Product Change Notice (PCN)

PCN Number: PCN-0485125R-01

Product(s) Affected: *CPM1201 Series (CPM1201-02A-02-FST-M7-67, CPM1201-03A-02-FST-M7-67, CPM1201-04A-02-FST-M7-67, CPM1201-05A-02-FST-M7-67, CPM1201-05B-02-FST-M7-67, CPM1201-08A-02-FST-M7-67, CPM1201-02A-02-FST-M9-67, CPM1201-03A-02-FST-M9-67, CPM1201-04A-02-FST-M9-67, CPM1201-05A-02-FST-M9-67, CPM1201-05B-02-FST-M9-67, CPM1201-08A-02-FST-M9-67)*

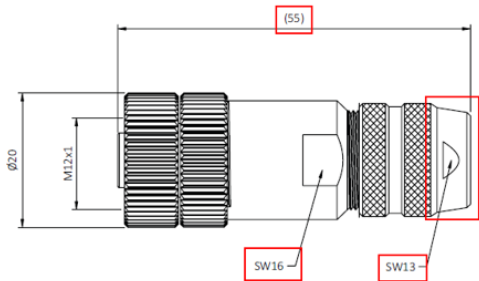
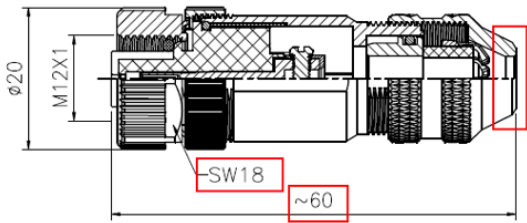
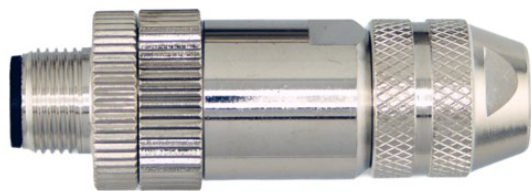
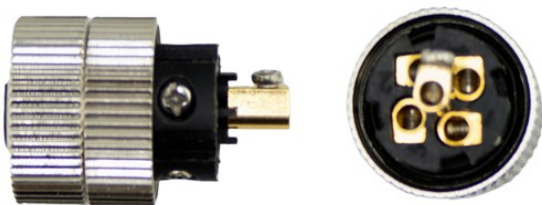
Visual differences

- Flat surface area on previously marked SW16 is now rounded
- Previously marked SW13 indentation is no longer visible on product
- New product now has a flat surface, marked SW18
- Surface area on new product is now smooth
- Screw head was previously a Philips and is now a slot head
